Addendum No. C

To the contract documents for NORTH VERDEMONT ELEMENTARY SCHOOL, DSA No. 04-122168

For the SAN BERNARDINO CITY SCHOOL DISTRICT

LPA Project No.: 30899

MATERIALS PLAN ENLARGEMENT

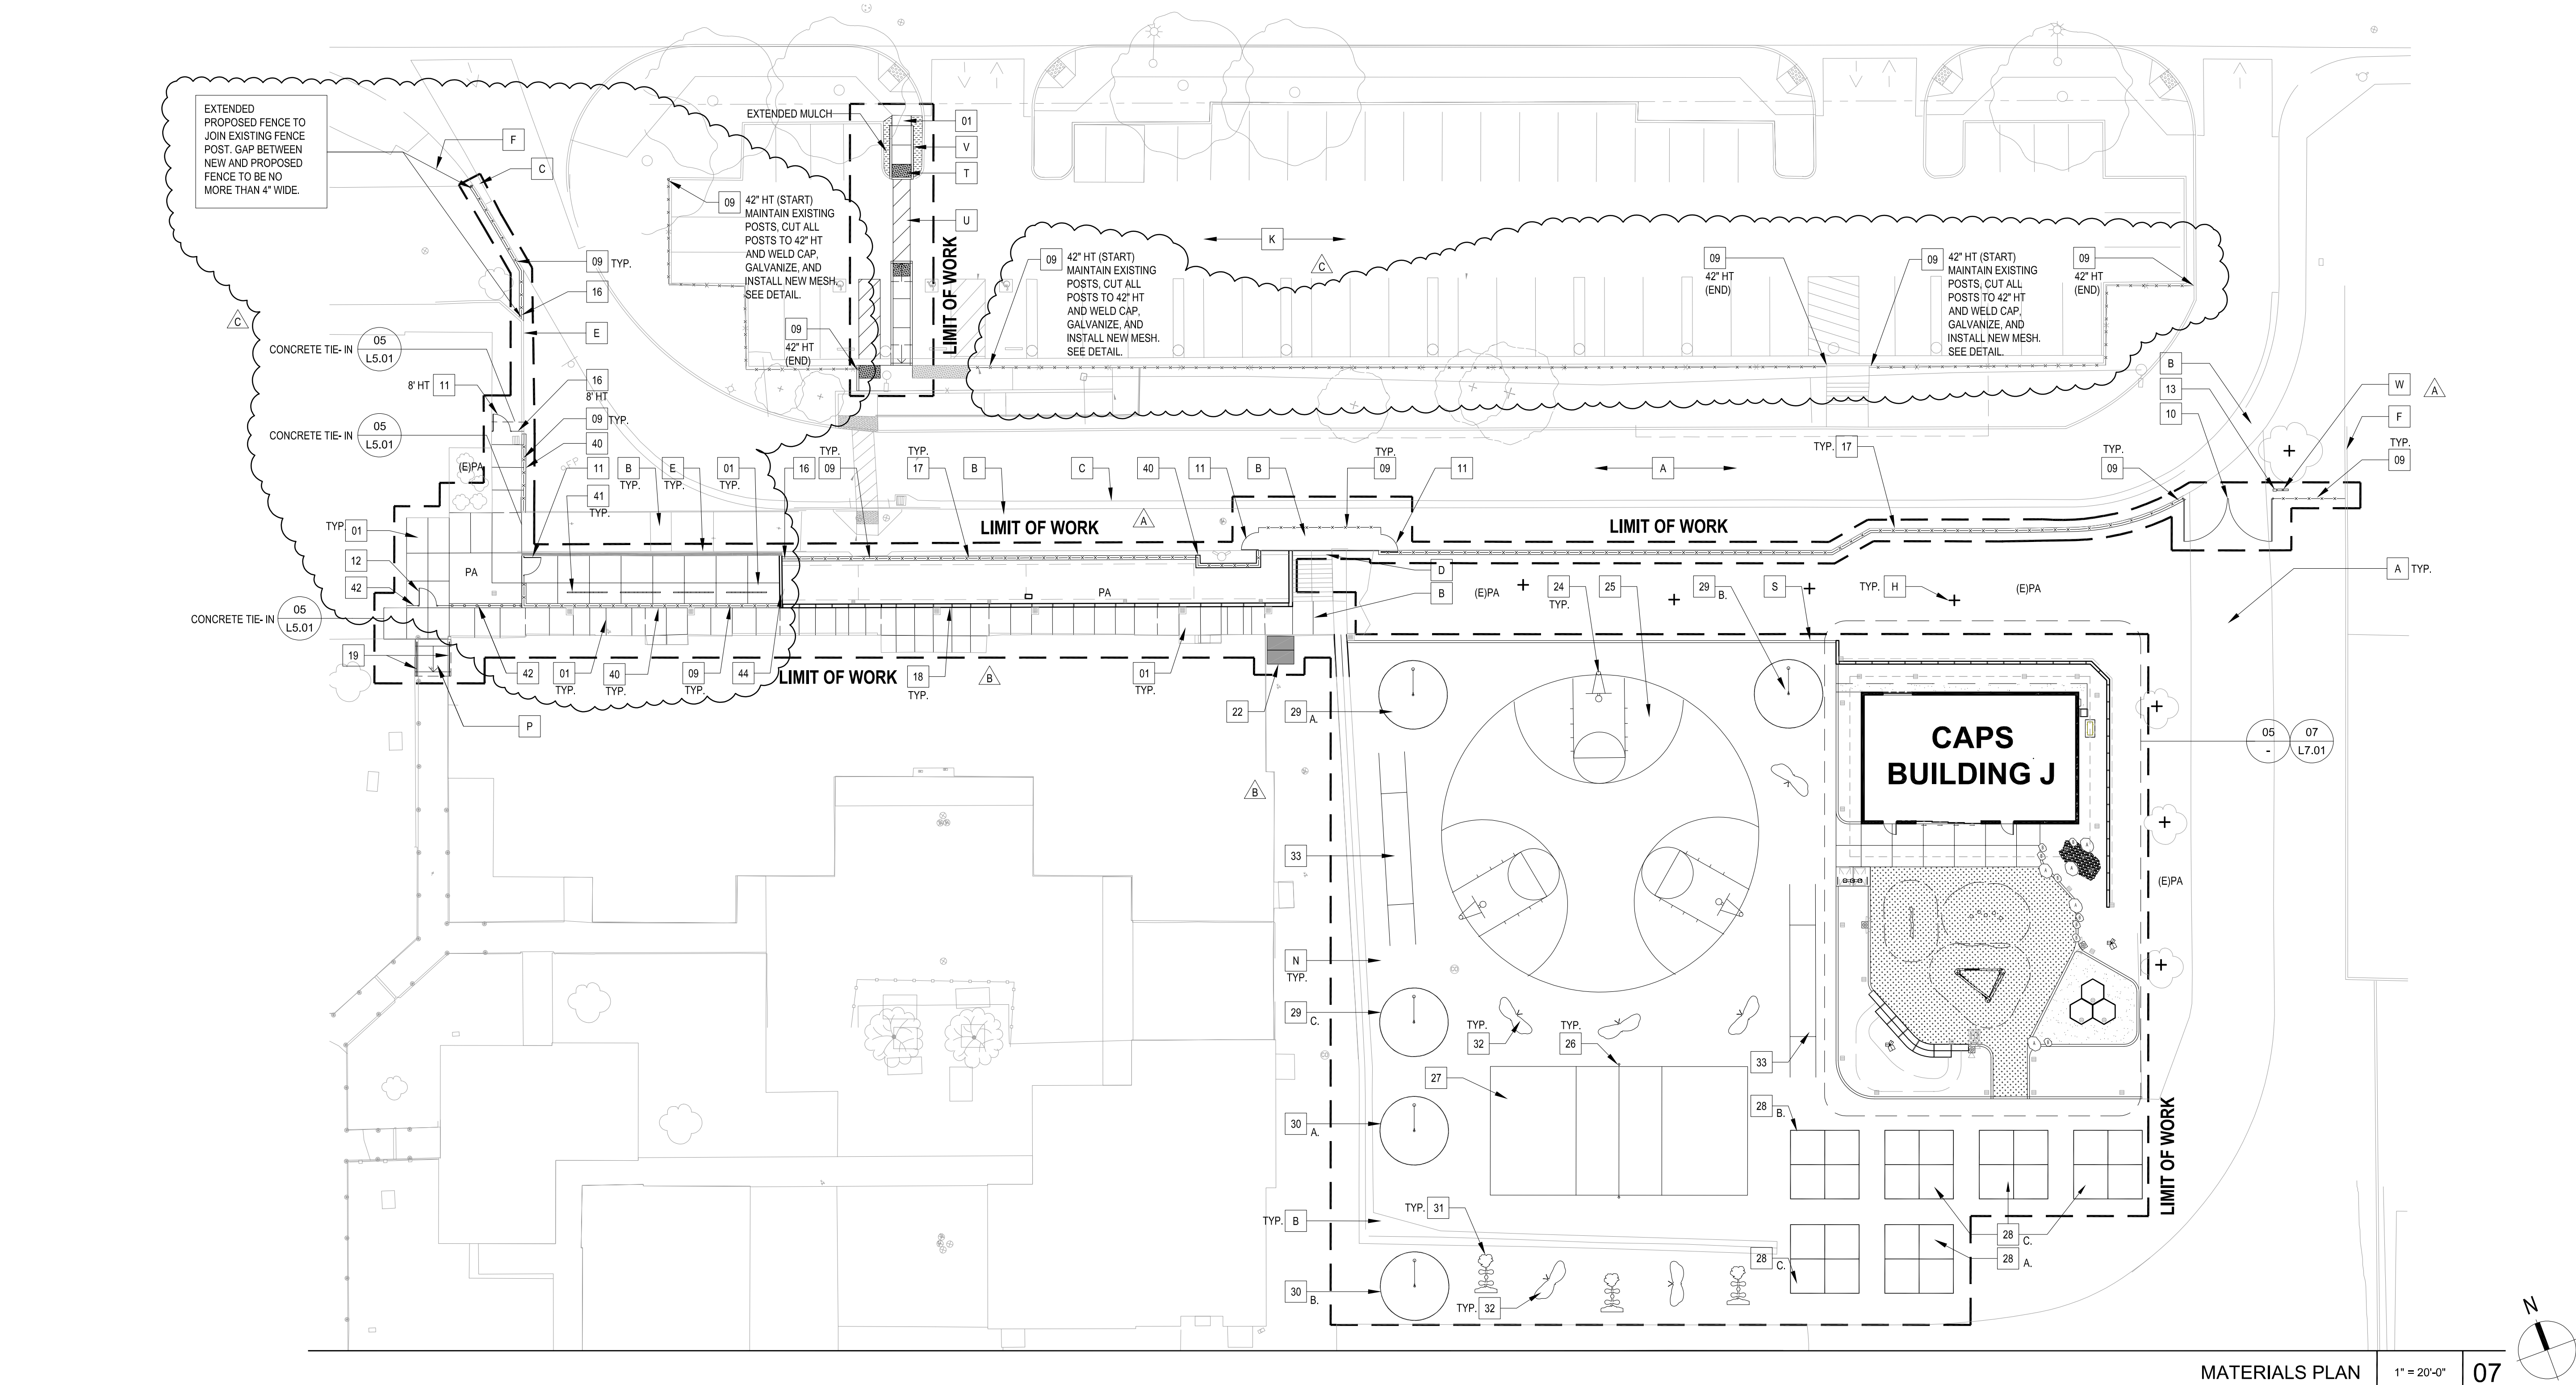
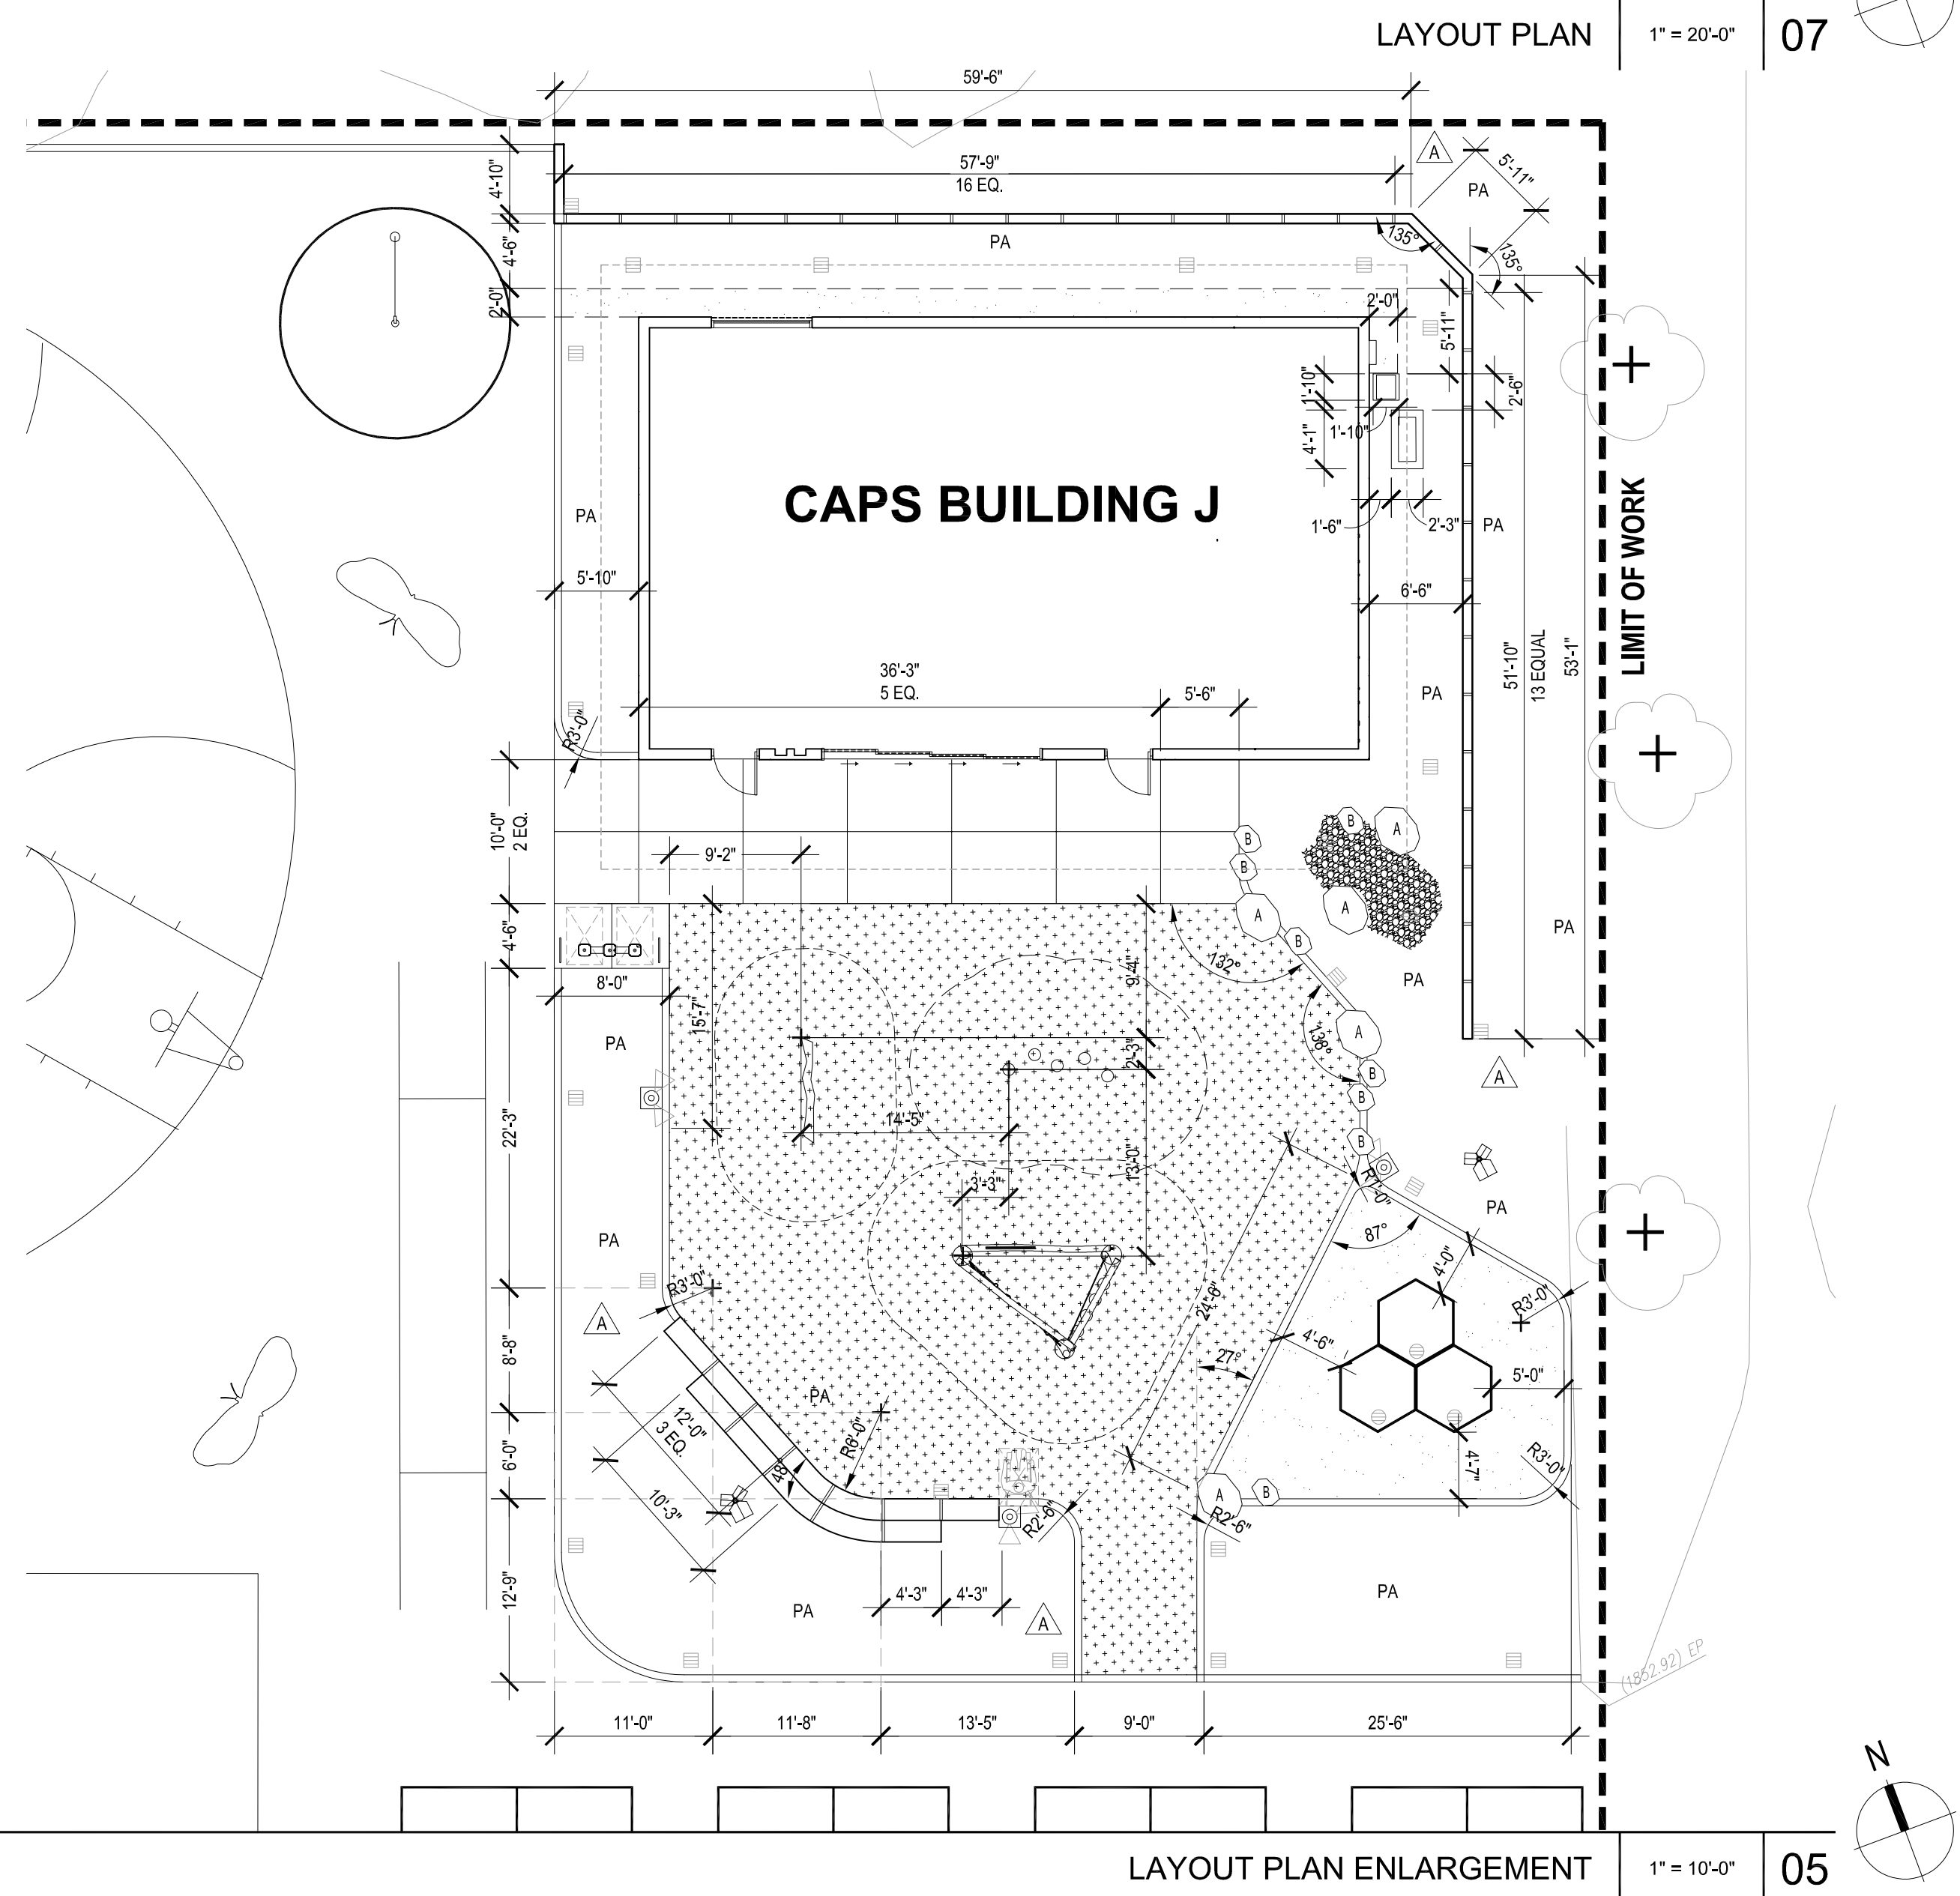
- a) Keynotes added.
- Item No. 14**      L1.01 – Materials Plan
  - a) Revised single point of entrance into campus.
  - b) Replaced existing bike racks with new.

- c) Added notes about reducing existing chainlink fence height.
- Item No. 15**      L2.01 – Layout Plan
  - a) Revised layout around single point of entrance into campus.
